# Site Accessibility Evaluation

**John "Prairie Dog"  
O'Byrne Park**

**Accessibility Evaluation**

SUBJECT: John "Prairie Dog" O'Byrne Park Self-Evaluation

Finding #3 Continued

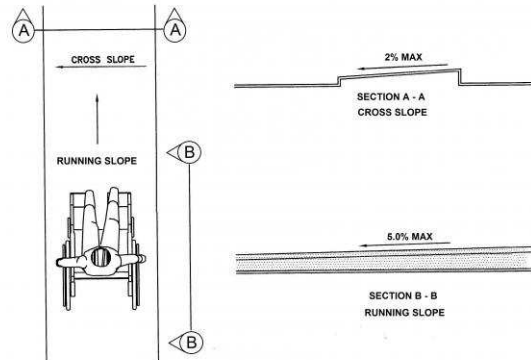
The accessible path of travel has cross slopes greater than 2%.

The stretch of accessible route that runs parallel to Bijou has four pads with cross slopes ranging from 2.5% to 2.8%.

Remove and replace pads.

Finding #4 Continued

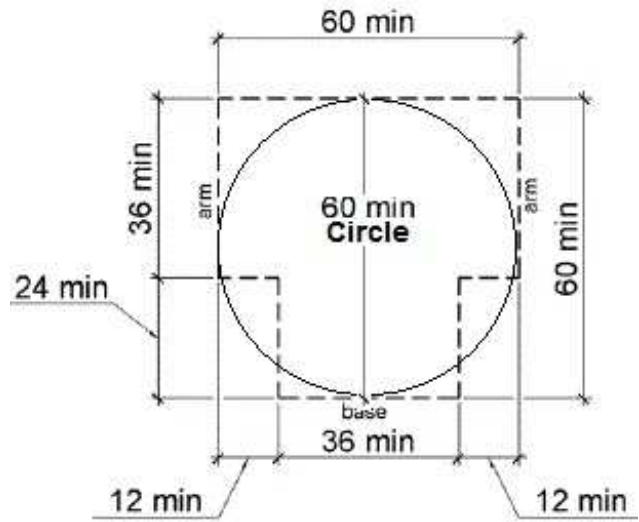
The T-shaped or circular turning space has excessive slopes.

The turn that branches toward the apartment complex has two pads with cross slopes as high as 3.3%.

Remove and replace pads.

Finding #5 Continued

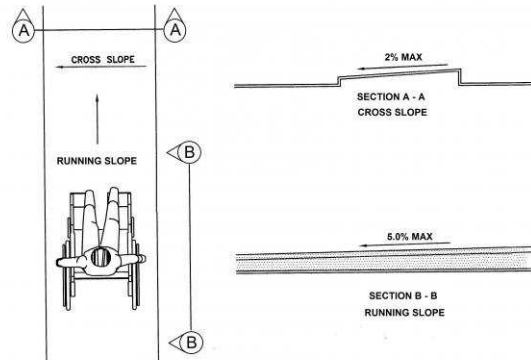
The accessible route on the site has running slopes greater than 5 percent and has not been constructed as a ramp (i.e. handrails, edge protection, etc.).

There is one pad on the route that branches toward the apartment complex that has a running slope of 6.2%.

Remove pad and adjacent pads, grade, and re-pour the pads to achieve a running slope of less than 5%.
